Re: Plains Pipeline Lovington Deep 6 release Site NMOCD Ref. AP-037

Plains Pipeline, L.P., respectfully requests NMOCD approval to conduct the following activities at the Lovington Deep 6" Release Site NMOCD Ref# AP-037. Plains proposes to install two (2) additional monitor wells (PMW-19 and PMW-20) at the site. The proposed monitor wells will aide in plume

Figure 3c - PSH Thickness & Groundwater Concentration Map - 09/12/2017

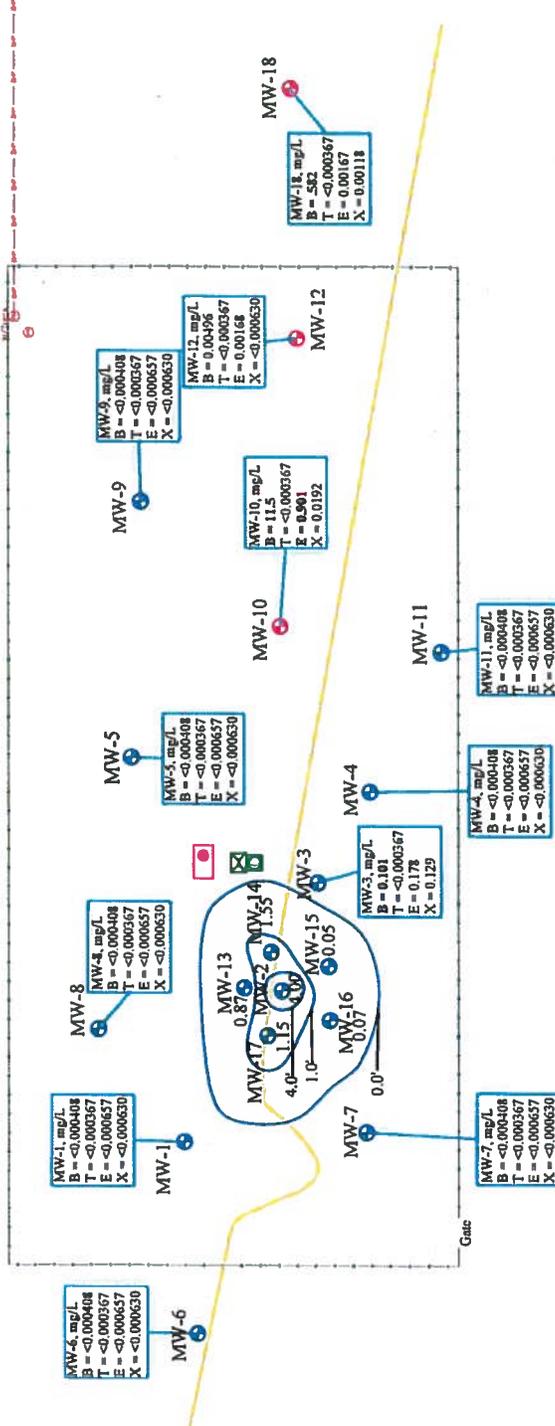
delineation and groundwater remediation efforts at the site. Monitor well PMW-19 is proposed to be installed to the northeast of existing well MW-18 and PMW-20 is proposed to be installed to the southeast of existing well MW-18. Please reference the attached Proposed Monitor Well Locations Map, Figures 2 and 3.

MW-19, proposed location

MW-20, proposed location

Post review of data, and assessing the recent work plan request submitted, that, and the information supplied within this email stream, the proposed work plan revision is hereby approved.

Please allow opportunity for District staff to attend placement and sampling of proposed wells.
